**Subject: Revision 1 of the Final Closure Report
Non-Asbestos-Containing On-Site Landfill
Permit Exempt “815” Facility #0971900014
Johns Manville, Waukegan, Lake County, Illinois**

Non-Asbestos Containing On-Site Landfill Construction Final Closure Report - State Facility ID# 0971900014

Revision 1

FIGURE 2

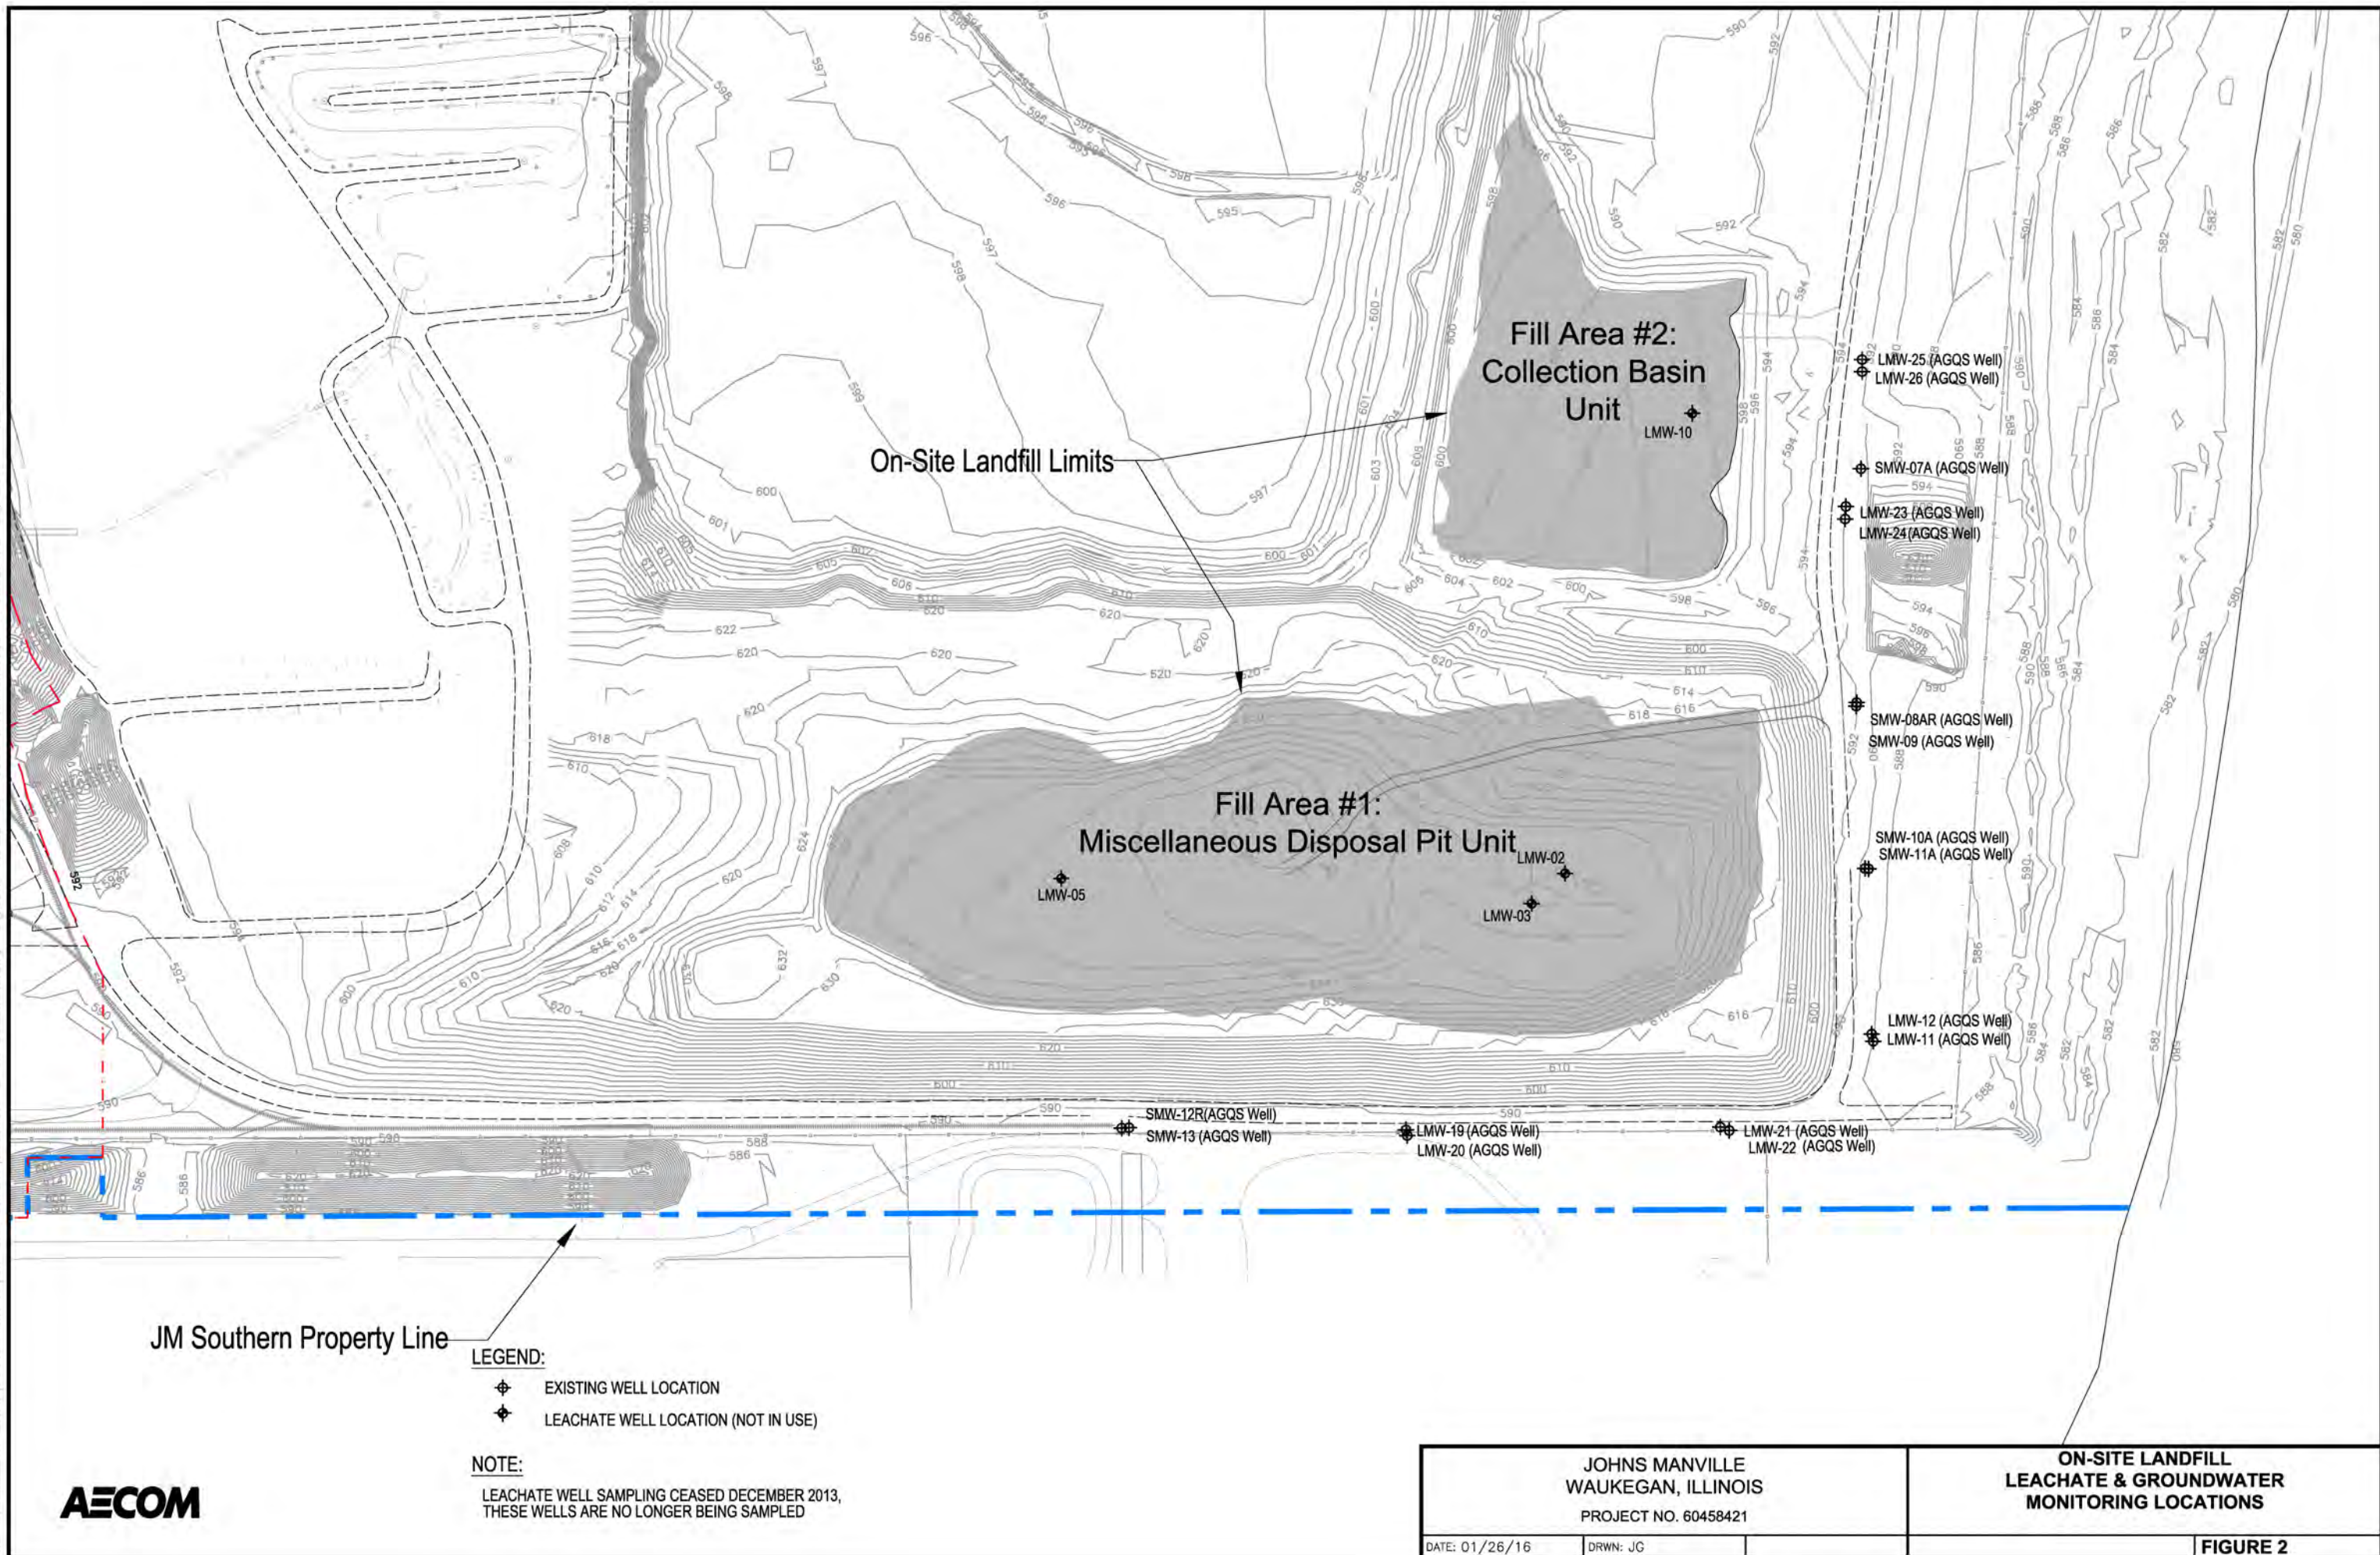
- Comment 15: *Section 4.1.3 of the closure report indicates that the monitoring wells for groundwater were installed during 20 through 26 Aug. 2008, and these wells were installed as described in Figure 8 of the 7 Dec. 2007 Adjusted Standard Order. The final locations for the groundwater monitoring wells are shown in the closure report in Figure 2 and Appendix B contains the well construction logs.*

Response 06: Stockpile Survey Map

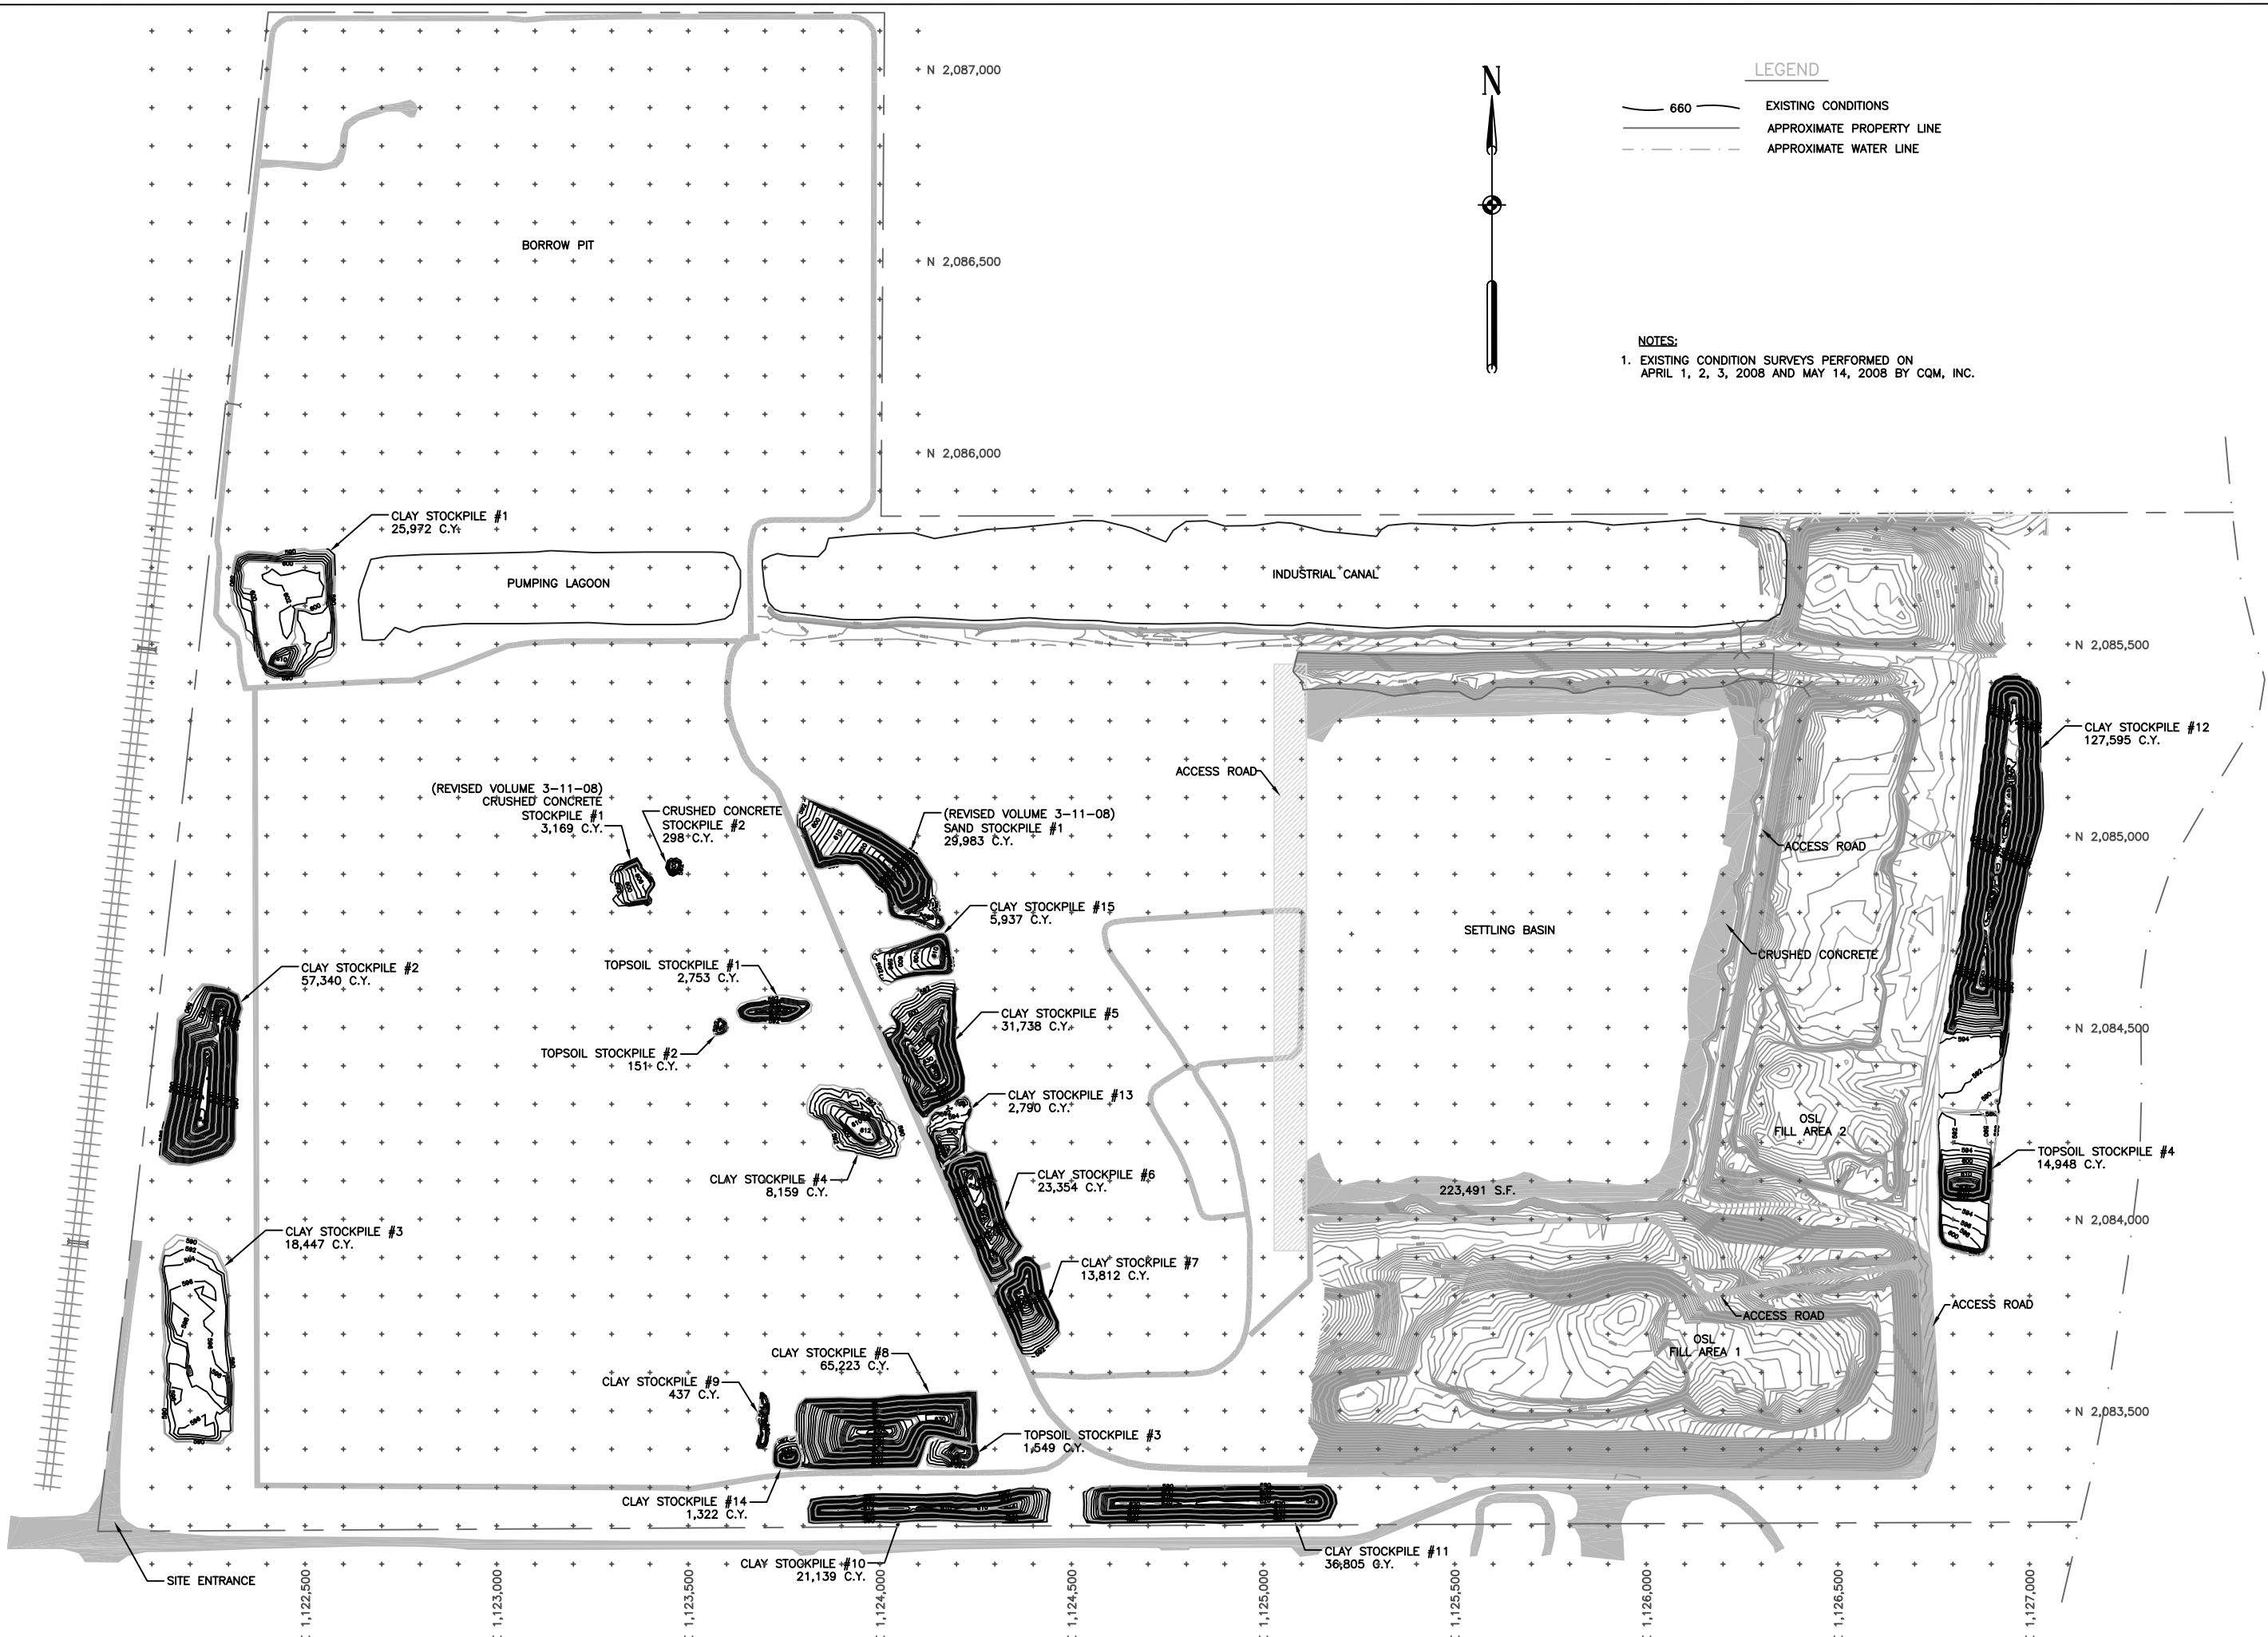
Comment 06: It is recommended that the CCR explain or provide the reference that describes the origin as well as the environmental and geotechnical quality of the Lake County clay used for the interim material layer that comprises the existing clay for the construction of large portions of the barrier layer. In addition, the report needs to provide the procedure used for surveying and determining the approved "Design Barrier Elevations" in Construction Drawing A-4 in the CCR for the different points and coordinates. Ultimately, the closure report should provide confirmation that the thickness of the barrier layer was a minimum of one foot and corresponded with the procedure and geotechnical information described in the approved RWP. The report also needs to verify that the site preparation and barrier layer construction procedures were in accordance with the RWP, and show the details regarding the areas where the Barrier Layer material for Fill Areas #1 and #2 was constructed, compacted,
